# M/s.Morayoor Granites Pvt Ltd

Ref: 1.MoEF&CC File No: IA-J-11015/82/2021-IA-II(NCM)

Sub: Seeking Environmental Clearance for Proposed Granite Building Stone Quarry of Morayoor Granites Pvt Ltd which is situated at Re Survey No.152/1-1, 152/1, 159/1-1, 159/1-2, 159/1-3, 160/1-1, 160/1-2, 160/1-3, 160/1-4, Re Survey Block No. 56 of Morayur Village, Kondotty Taluk, Malappuram District, Kerala for an area of 4.9797 hectares under B2 category.

The application is considered in Minutes of 6<sup>th</sup> EAC (Non-Coal Mining) meeting held during 9<sup>th</sup> – 11<sup>th</sup> November, 2022, directed to clarify on for following details, please find below the point wise reply to the queries raised.

### Bench Formation Details

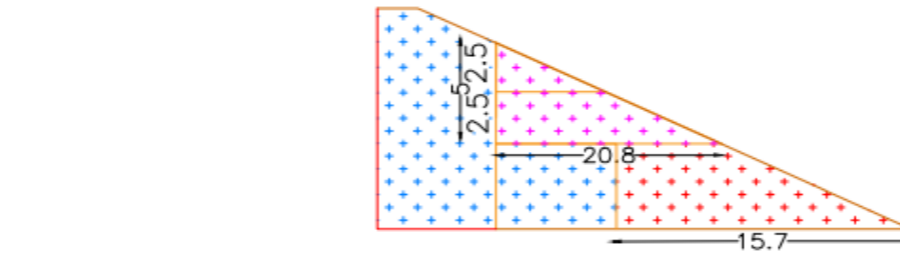
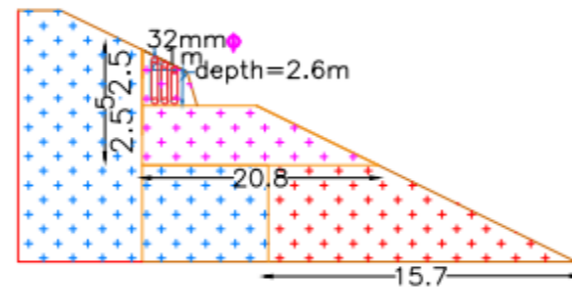
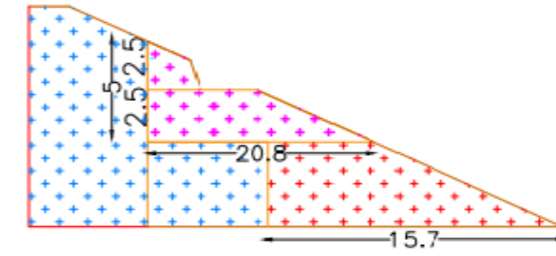
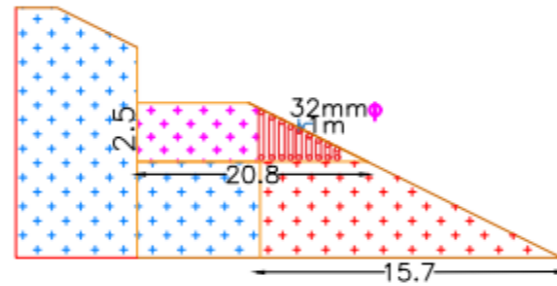
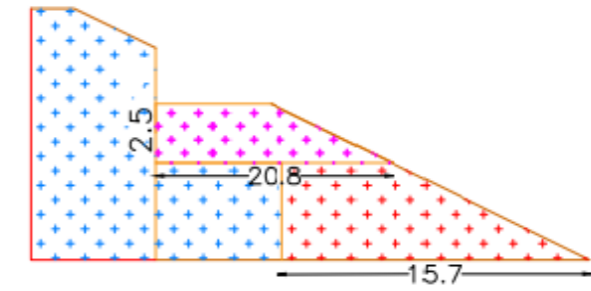
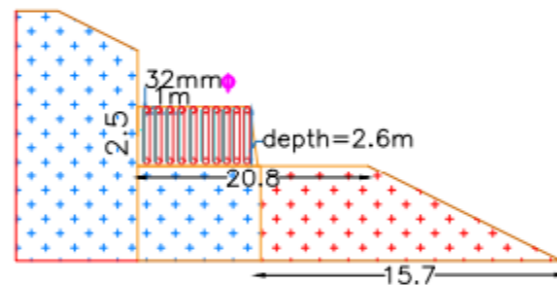
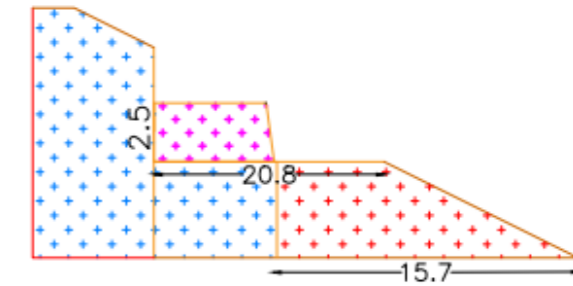
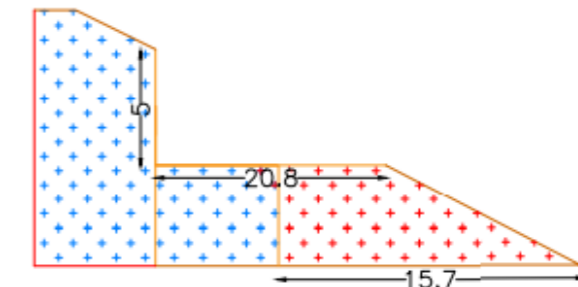
**1.The EAC noted that the production by jack hammer drilling is not sufficient to produce 650 TPD. The EAC asked the Project Proponent to revisit the methodology of the mining adopted specifically relating to Bench height, Drilling and Blasting and accordingly the project proponent needs to submit the comprehensive note on methodology of mining with proper justification. Accordingly, the mining plan needs to be revised.**

To maintain the bench height of 5m, sub-bench of 2.5m will be formed first (*Stage 3 in the above mentioned figure*), later on two benches of 2.5m will be merged and one bench of 5m will be formed (*Stage 4 in the above mentioned figure*) and maintained. The detailed representation of Bench Height Formation is provided above. The same approach was considered in the Mining Plan approved by District Geologist and the same has been detailed in the above figure.

*Figure 1: Traffic Study Locations*

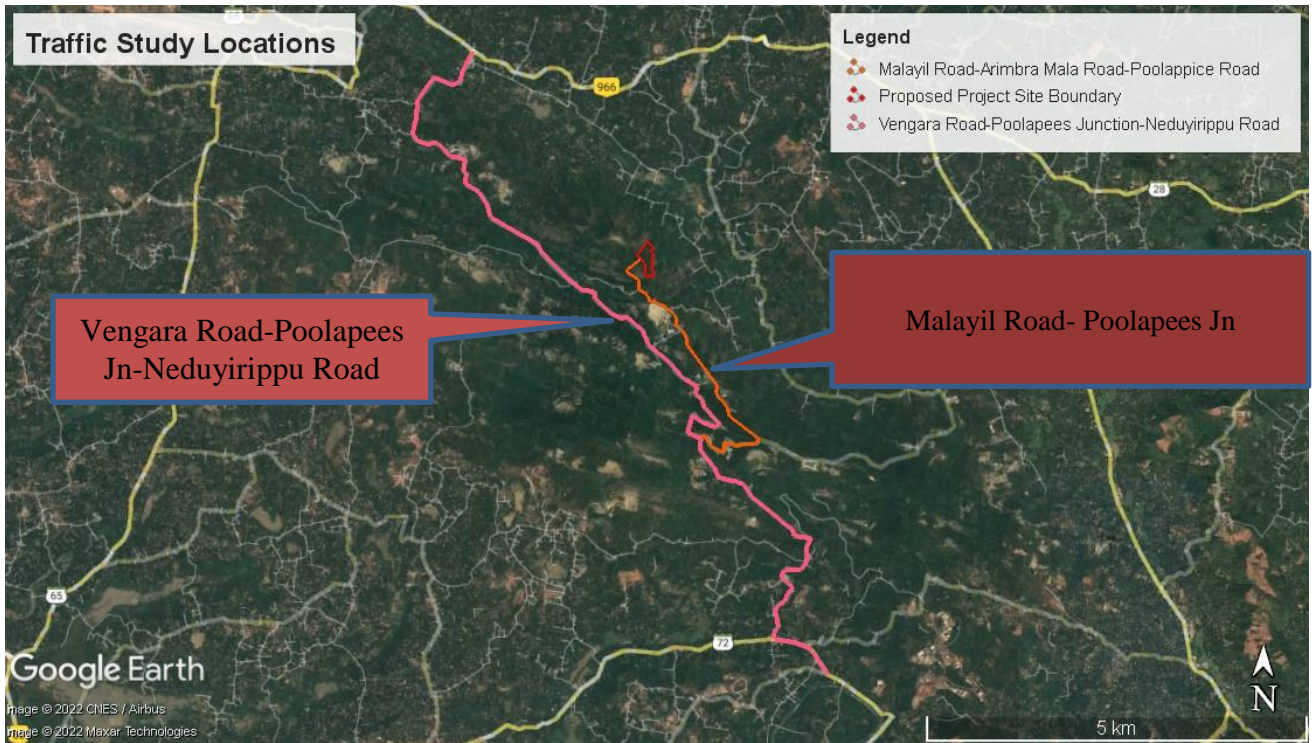
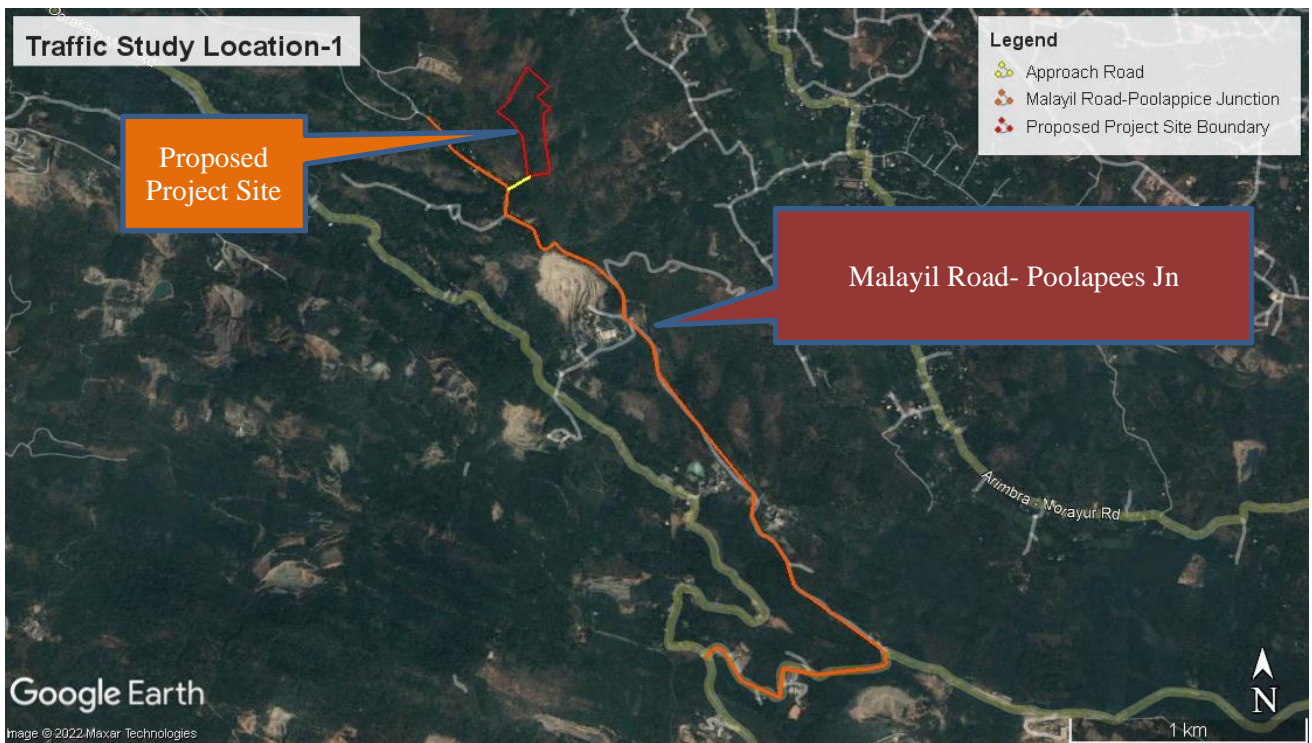
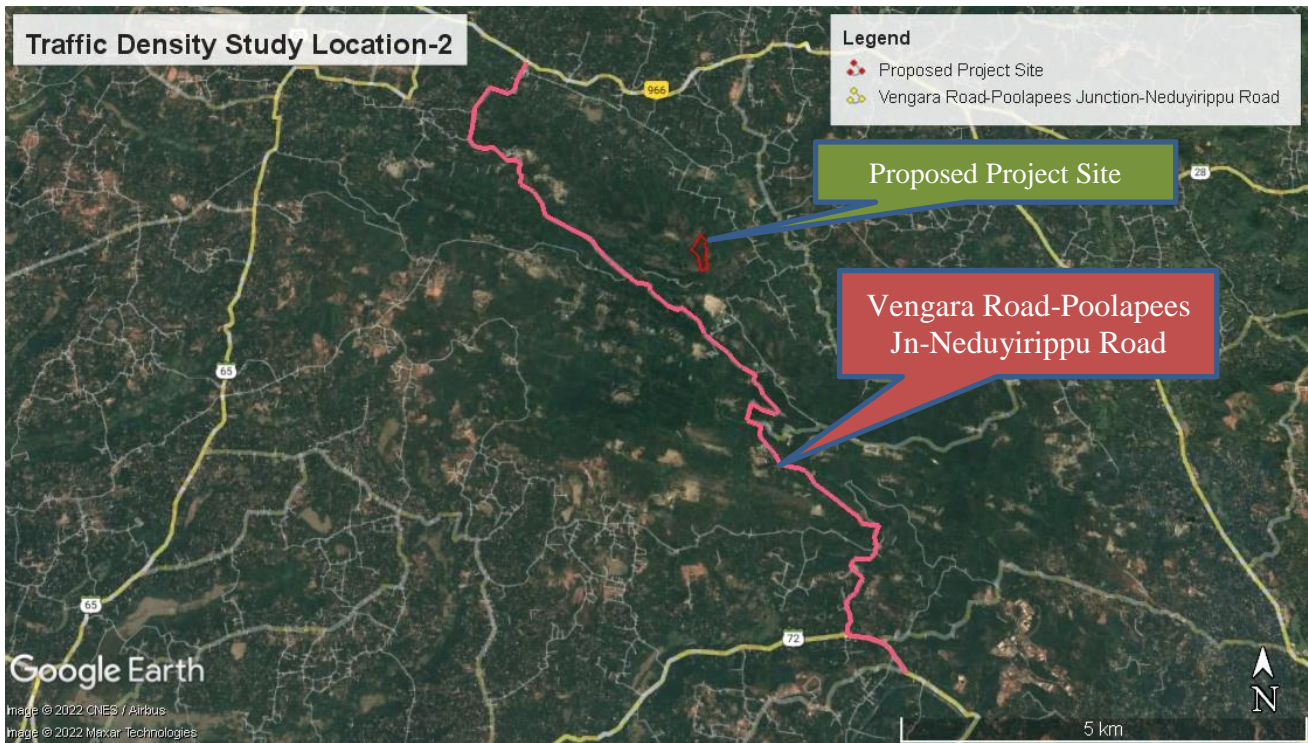
**2.The EAC opined that the proposed transportation is passing through the village road and hence asked the Project Proponent to conduct the traffic study as the PP is proposing to transport 140-150 no.of trips/day and also the measures and action plan to be taken to strengthen and maintenance of the approach road. PP should explore the possibility of bypassing the village road for transportation purpose and accordingly submit the map for transportation route.**

A Traffic Study was conducted to determine the vehicular traffic measures and best possible route for material transportation from mines to destination points. It is proposed to take the material to different destination in routes.

Currently we had proposed, the approach road from the quarry site can be accessible via Arimbra – Morayur road a village road which is connected to NH966. Since the existing proposal was changed because the road passes through a populated area. Hence instead of this Road, an alternative route was considered for the Traffic Study which is currently using regular truck movement with sufficient capacity. The approach road connects the proposed project site with Malayil Road and then it reaches the Poolapees Junction where it connects to Vengara Road-Poolapees Jn-Neduyirippu Road, connects NH 966. Both stretches have a minimum width of 7m which is sufficient to cater the additional traffic loads expected from the proposed project.

**Figure 04: Google Image of Afforestation proposed outside of the Lease Area**

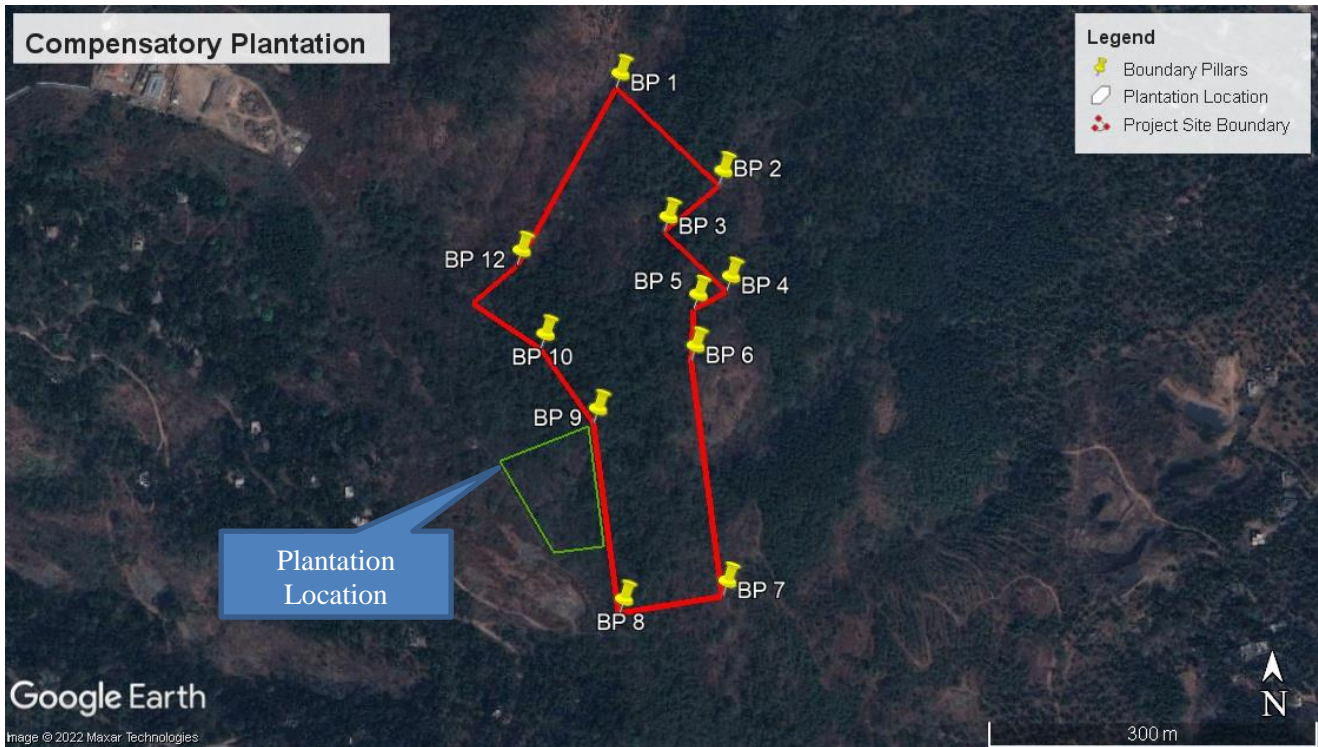
**3.The Project Proponent needs to refer the Central Pollution Control Board (CPCB) Guidelines for developing greenbelts and to rework on the spacing proposed for development of greenbelt and also to provide the no. of trees cut in the mine lease area and the compensatory afforestation plan, along with the no. of species to be planted and the type of species to be planted.**

As a compensation of loss of trees within the core area, planation will be carried out side the lease area, more in the dry area in Survey No 160/1-2 for an area of 0.6516Ha. Yearly, we will plant about 217no's of trees for 5years.Totally we will plant around 1085no's of trees within the same area, expecting survival rate of 90-95% with a plant interval of 2x3m wide. Five year afforestation plan outside the quarry area is as follows.
